## PLAN COMMISSION MEETING AGENDA

# Plan Commission Report

**PROJECT:** Plan Review – Jim Kaiser, PCA Architecture for US Bank

**ADDRESS:** 130 W. Town Square Way

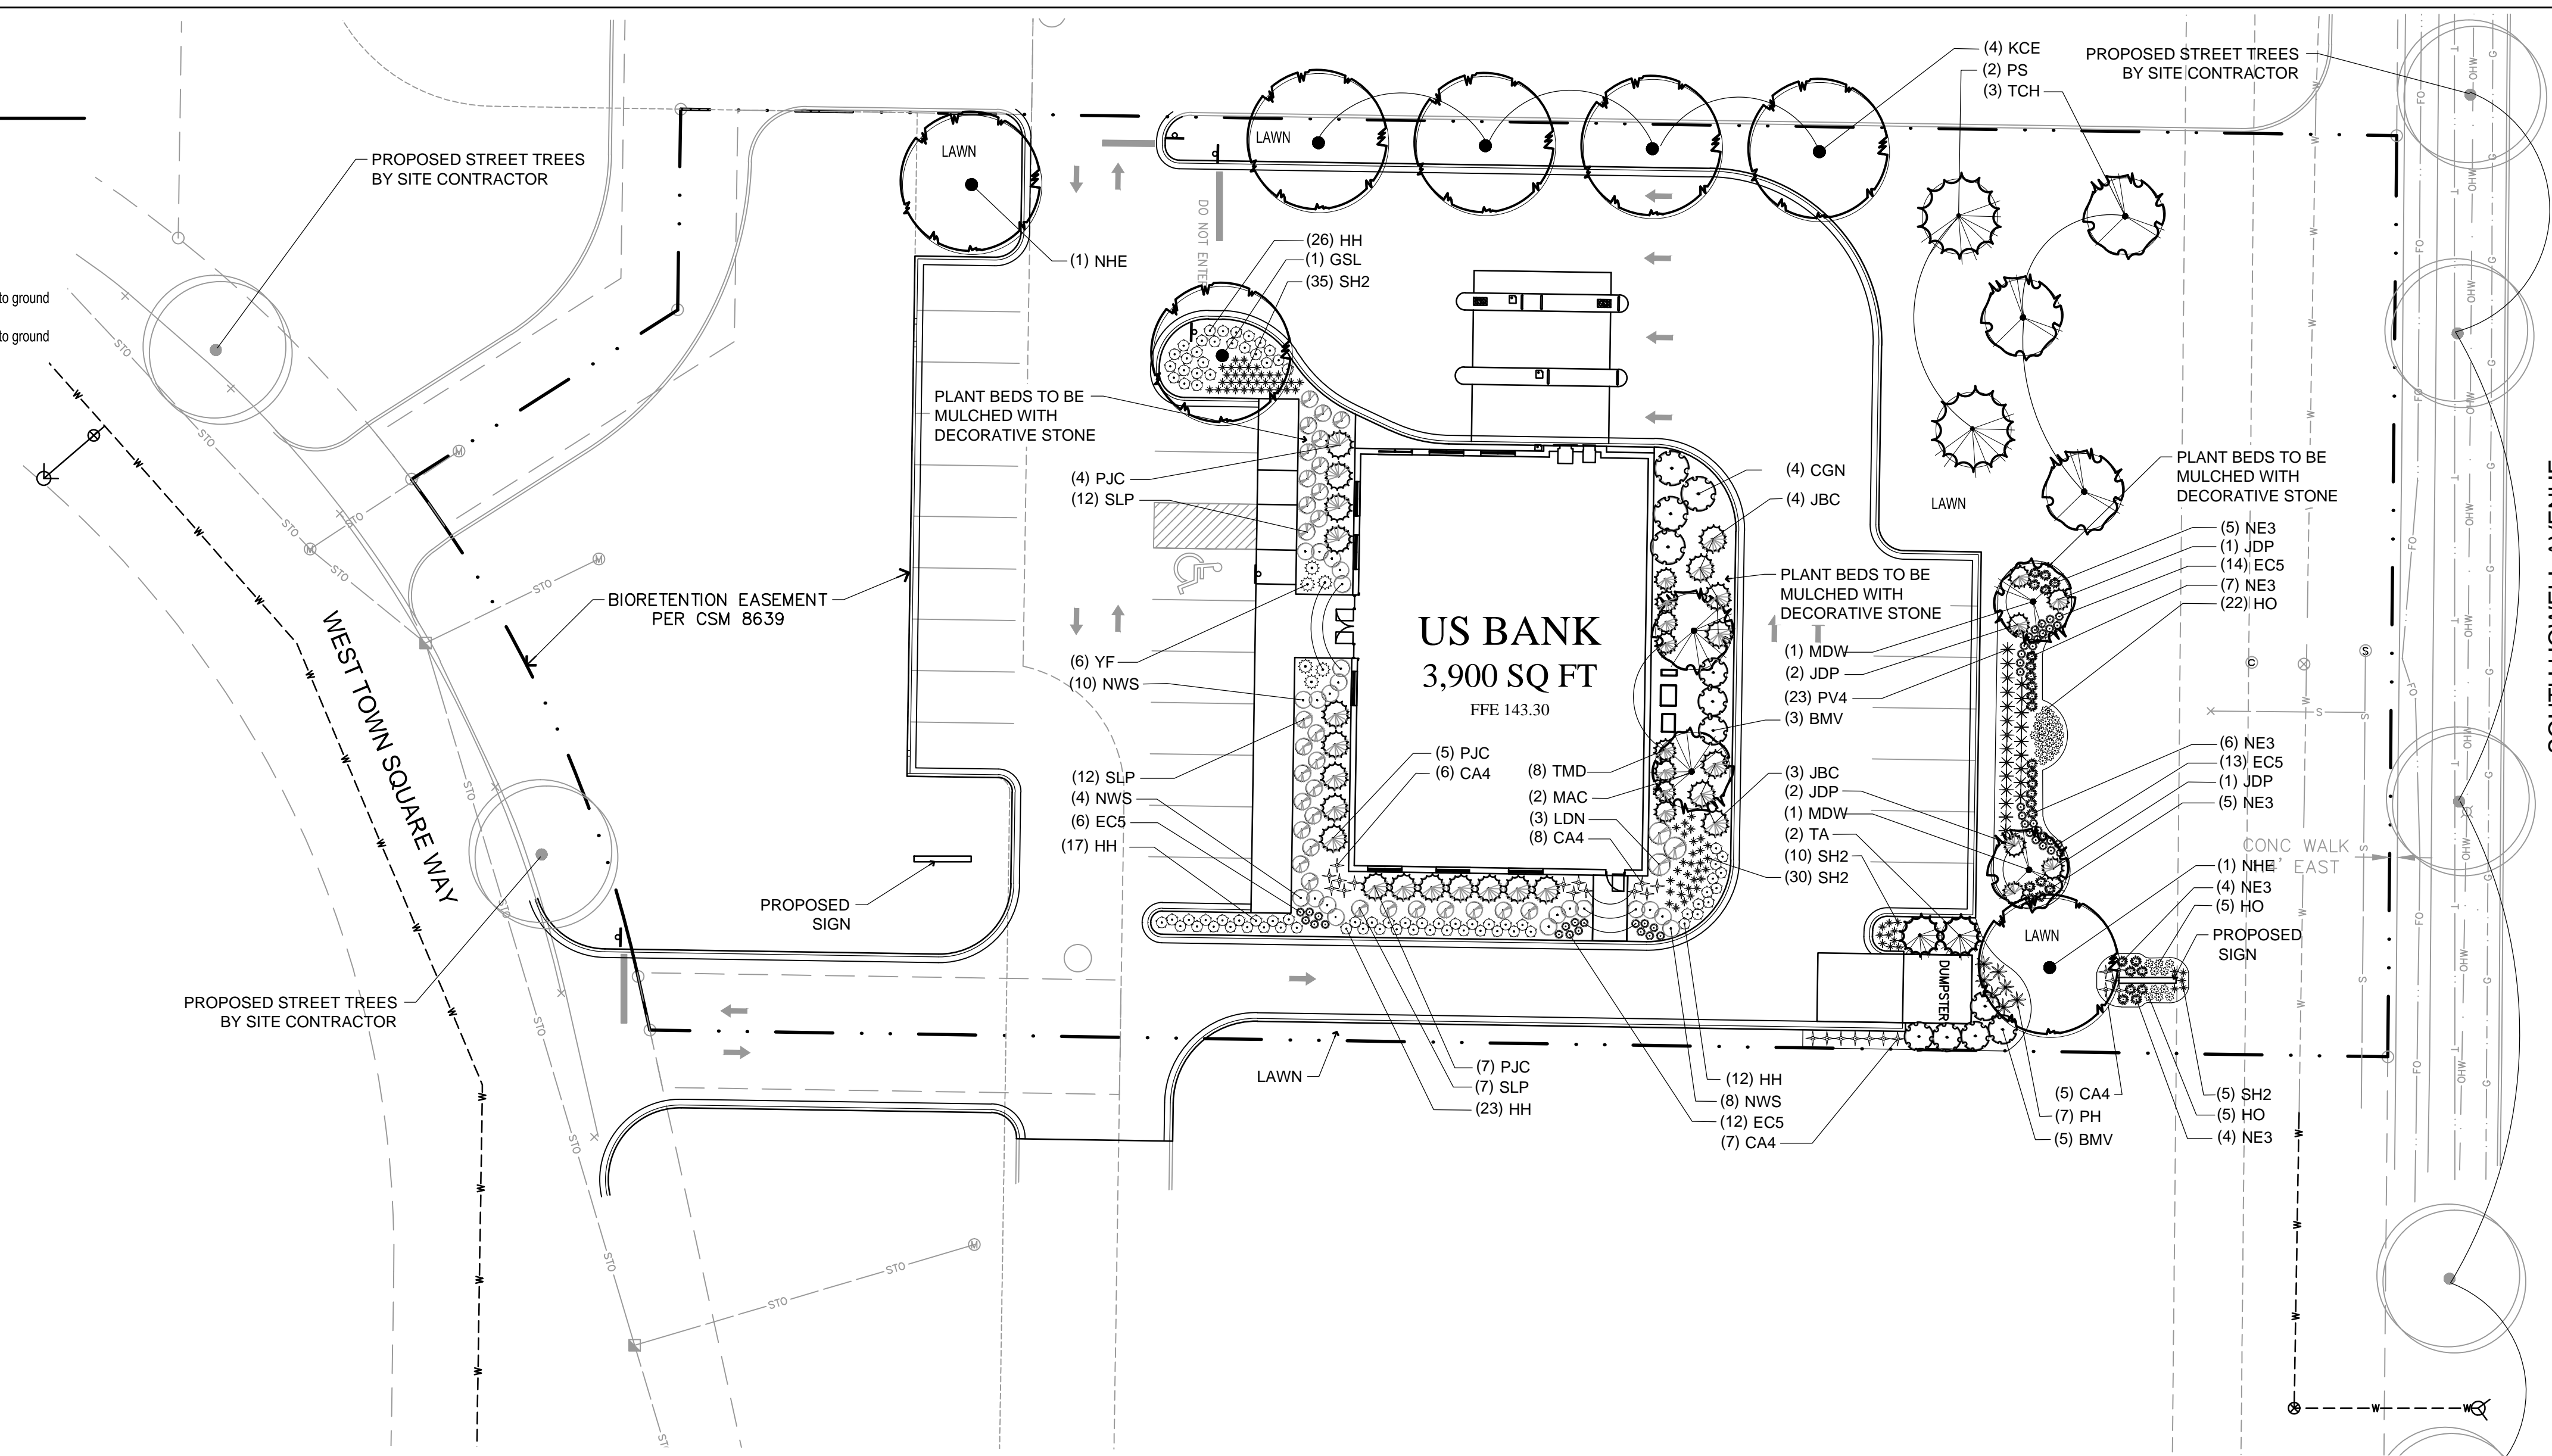
Unless the Commission directs otherwise, the final landscape plans will be approved by the Director of Community Development prior to the issuance of building permits. The landscaping plan will need to meet the requirements of the Landscape Zone (LZ) to the extent that it is allowable within the bioretention area.

Part of the streetscape also includes the treatment of stormwater. Although stormwater for the entire Drexel Town Square development is being designed as a whole, there remain requirements to address stormwater quality on a site - specific basis. Based on the submitted landscaping plan, the site meets the requirements for open/green space. However, the landscape plan overall requires additional treatments on the east as mentioned previously. It is also recommended that, if possible, the parking area on the west be moved such that there is sufficient space for planting vegetative screening. Landscape elements, rather than lawn, should continue along the southern property line.

3. That all landscaping plans are submitted for review and approval by the Director of Community Development prior to the issuance of building permits.

**WEST ELEVATION**

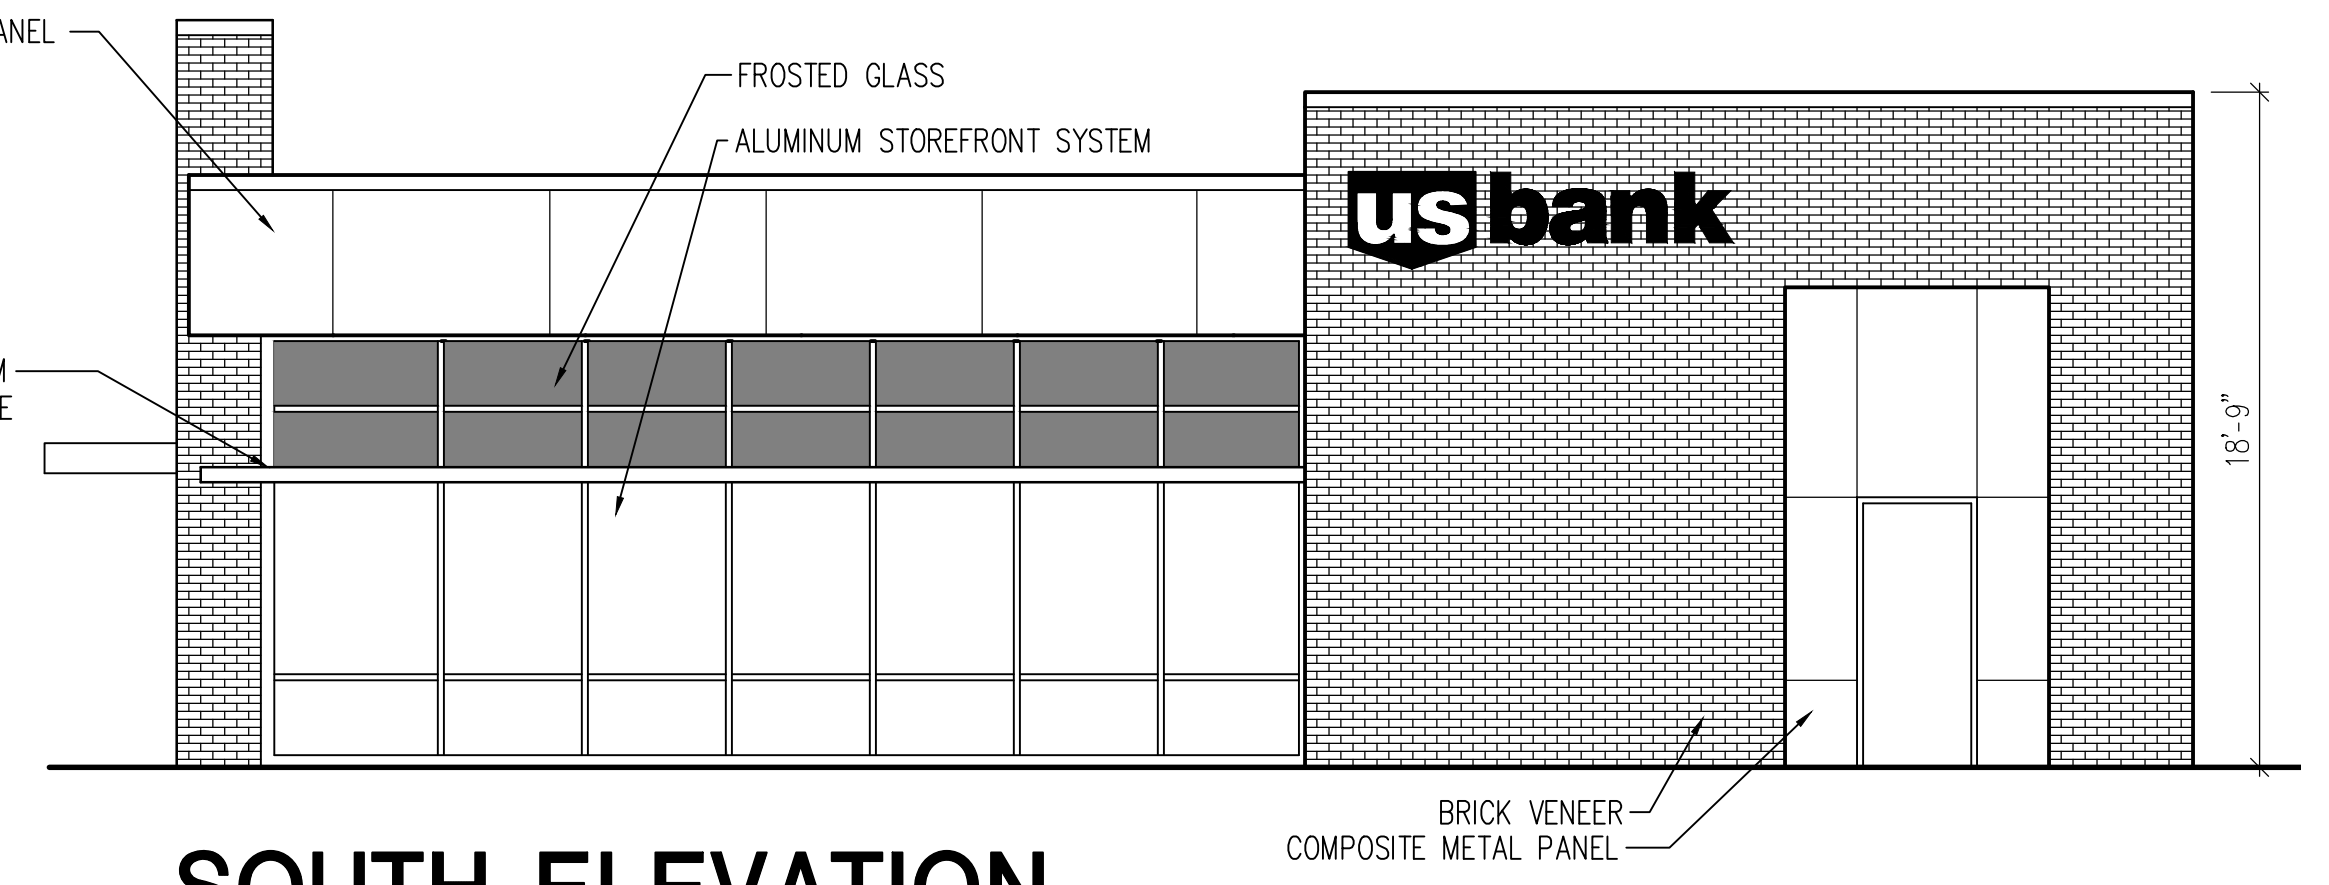
Aluminum storefronts are shown on both sides of the entry façade parapet on the west, which wraps around the southwest corner to meet the brick tower. On the west elevation glass and brick veneer comprise a majority of the building materials (89%), with 11% being composite metal panel. Of the overall 41% glazing proposed on the west elevation, a majority (25% of the facade) is clear glass, and 16% is either spandrel or frosted glass. Spandrel is proposed along the bottom of the northwest storefront, with frosted glass above both storefronts and the entry. A minimum of 30% clear glazing is required on this elevation as it is considered a primary entry façade.

All window elements are recessed from the parapets and tower elements to give the building depth and create an appearance of multiple façade layers. Composite metal panel provides an awning over the entry, and aluminum sunshades are shown on the southwest and south. Staff suggests adding aluminum sunshades over the aluminum storefront system on the east elevation to add to the visual depth. Adding the sunshade on this elevation will qualify as an alternative to street level clear window glazing requirements. The addition of sconces or planters will also help to enhance the building façade in lieu of meeting street level clear glazing percentage requirements.

**SOUTH ELEVATION**

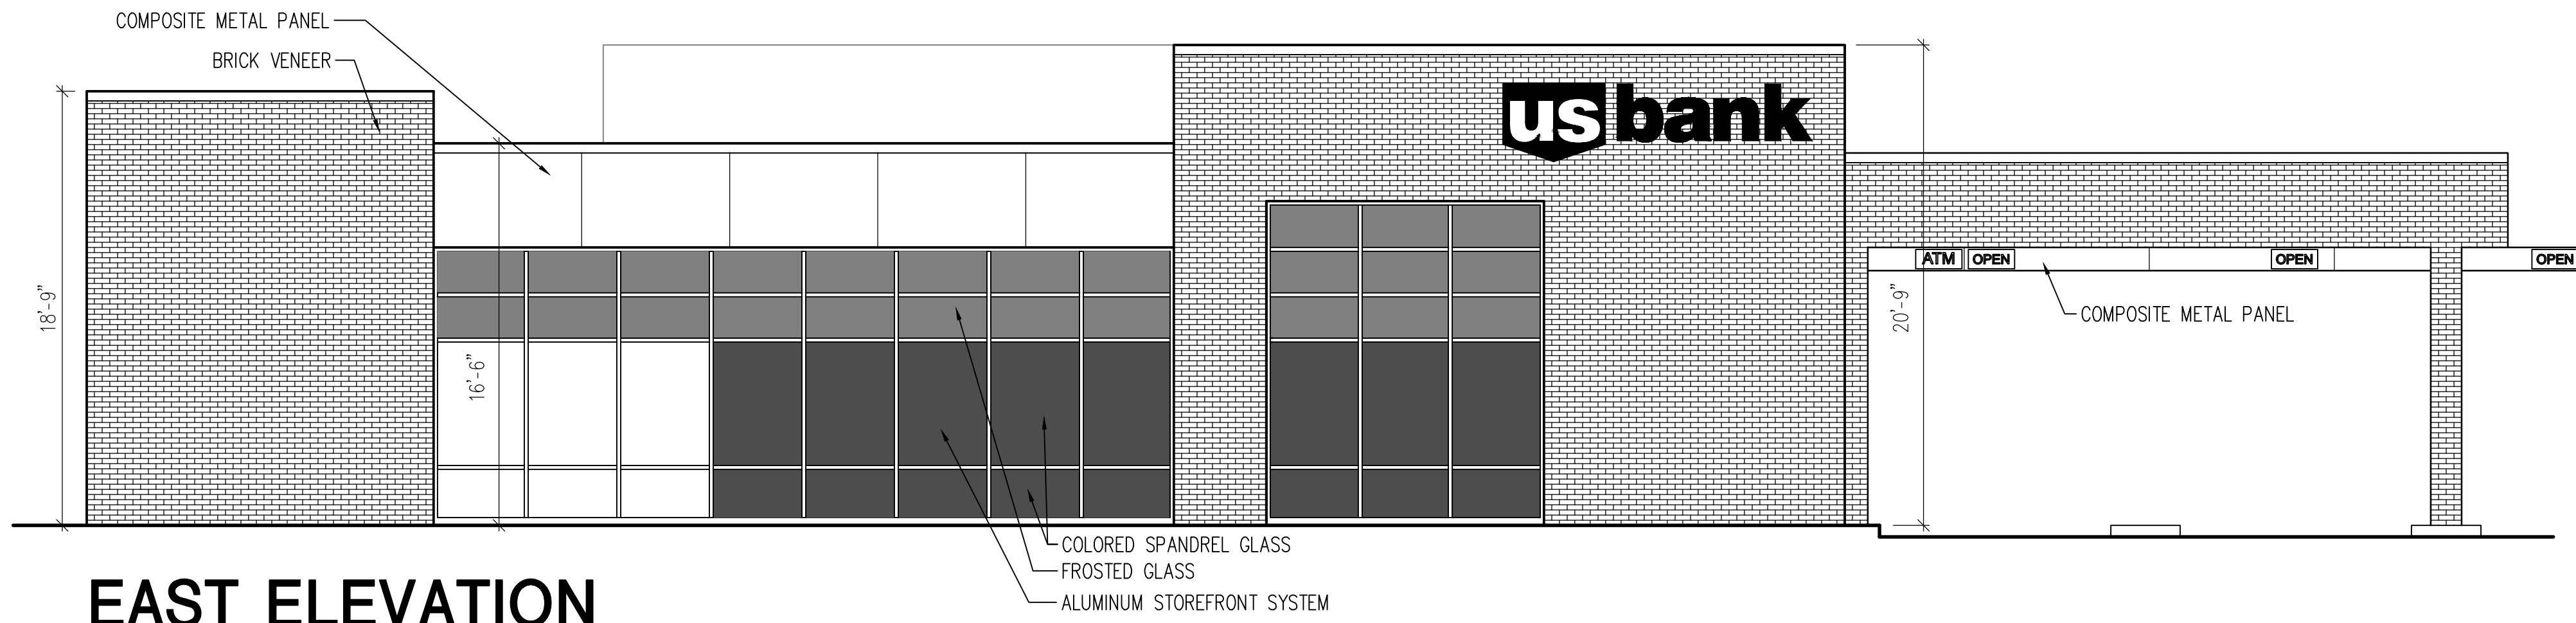
On the south elevation clear glazing is at 23% and frosted glazing is at 12%. The location of the clear and frosted glazing matches that on the west elevation. Brick veneer is shown at 40%, with composite metal panels providing the remaining 25% of the façade. A minimum of 20% clear glazing is required on this elevation as it is considered a non-entry façade. Up to 50% of the required glazing may be spandrel glazing on this elevation.

**EAST ELEVATION**

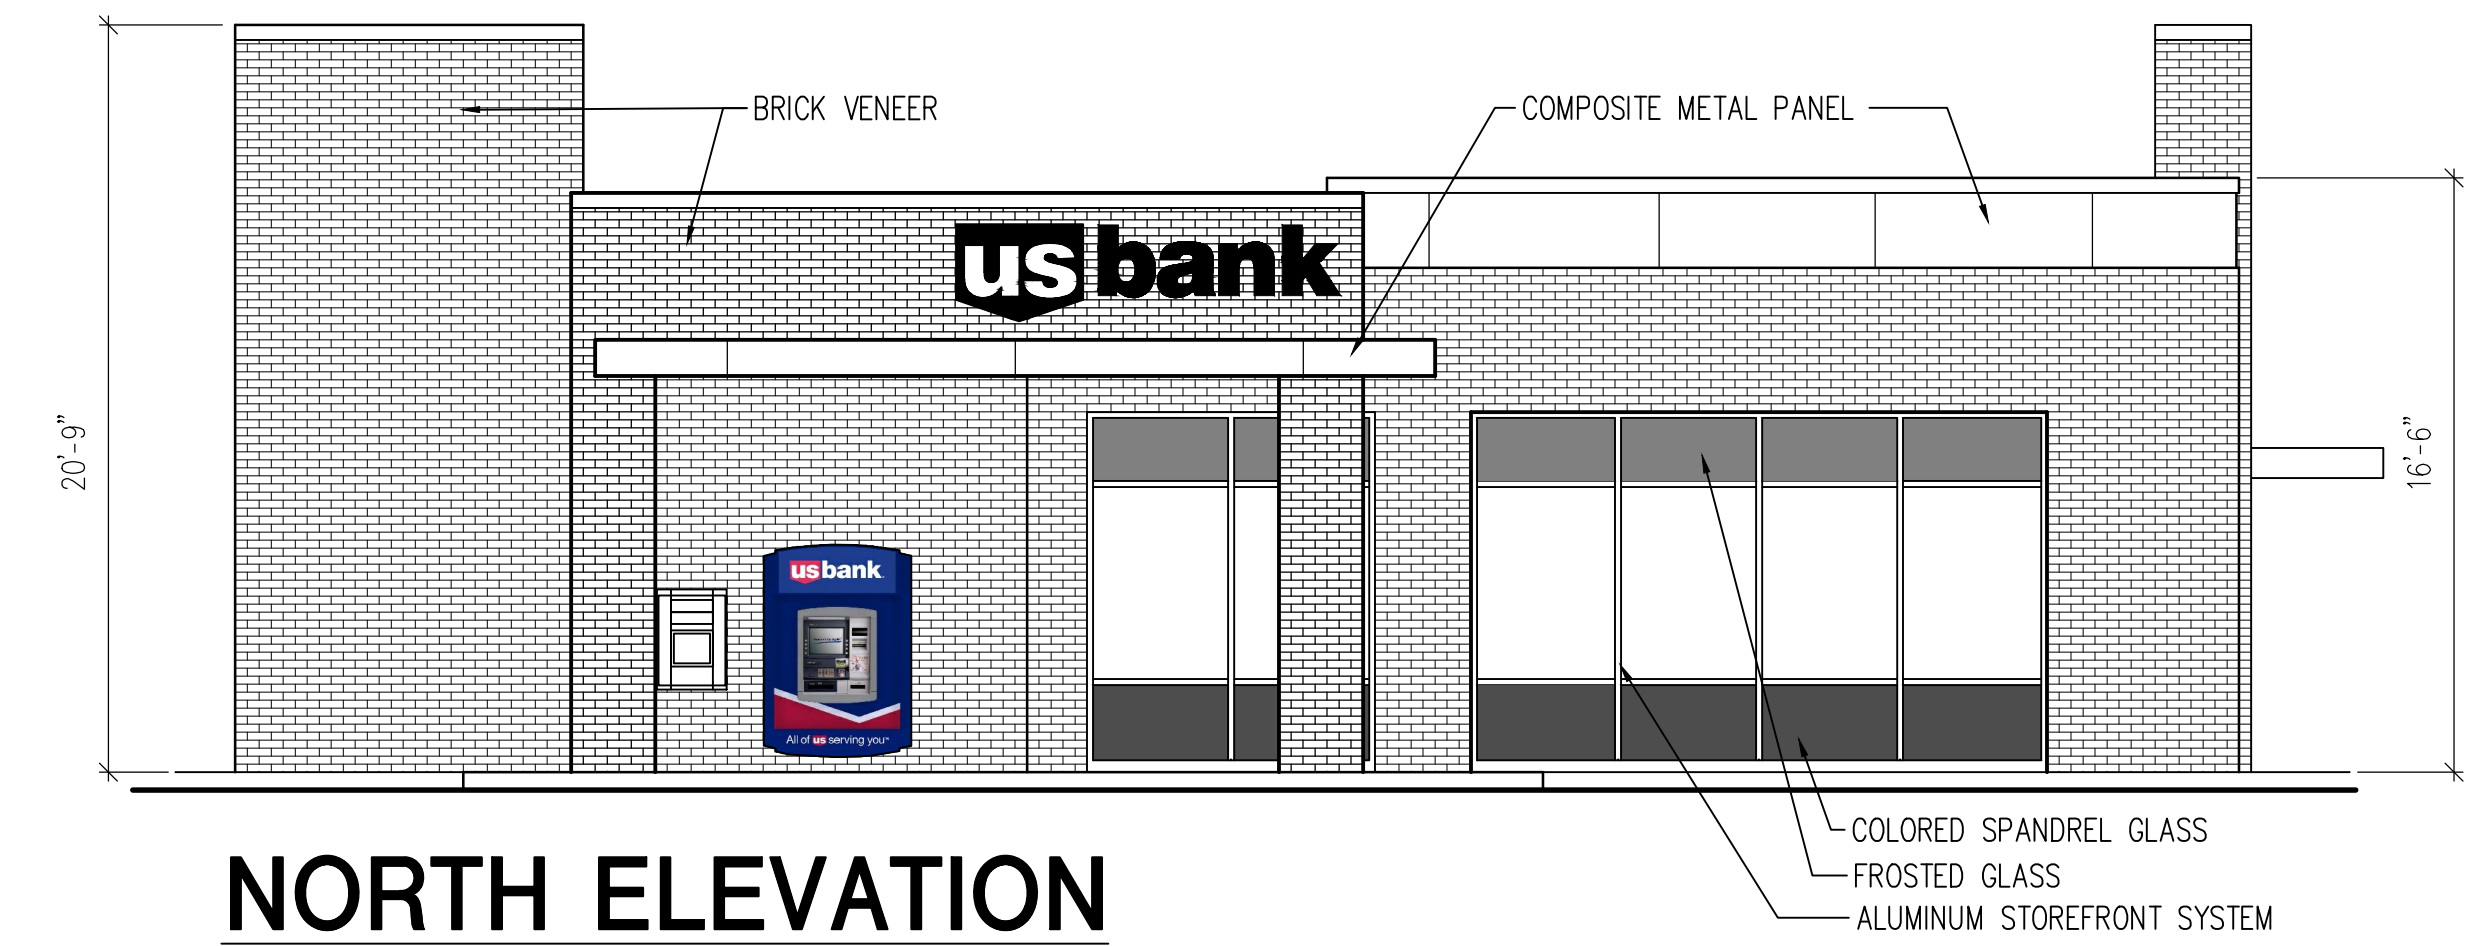
The aluminum storefront is also incorporated on the east elevation between the tower and parapet. Although the total glazing on this elevation is shown at 39%, a majority is frosted and spandrel glazing as this is where the "back of house" operations are expected to be within the building. Clear glazing comprises only 7% of the elevation, while 18% is proposed to be spandrel and 14% is proposed to be frosted glass. Brick veneer is the dominant building material on this façade, with 10% proposed to be composite metal panel. A minimum of 30% clear glazing is required on this elevation as it is considered a special condition façade, which requires the same treatment as a primary entry facade.
